Subject: Minutes of 47th Protection Sub-Committee Meeting.

47th Protection Sub-Committee Meeting (23rd June, 2023)-MoM

**47th Meeting of Protection Sub-Committee (PSC) of
Northern Regional Power Committee**

Date and time of meeting : 23.06.2023 11.00 Hrs.
Venue : Video-Conferencing

I. **Multiple elements tripping at 220kV Moga(PG) and 220kV Mogan(PS) on 24th March 2023, 19:07 hrs**

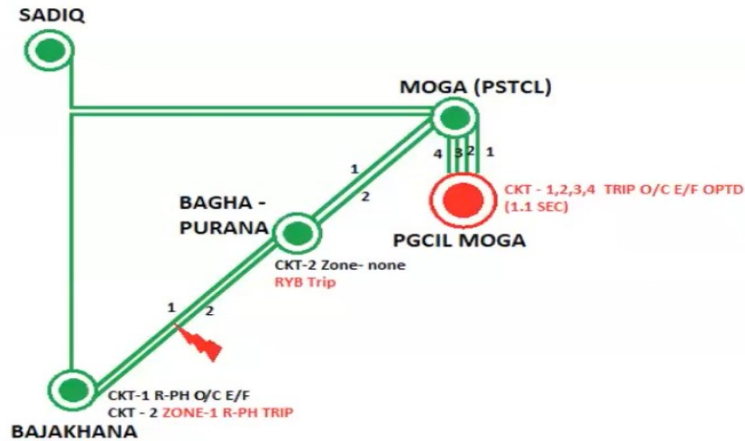
1. Discussion during the meeting:
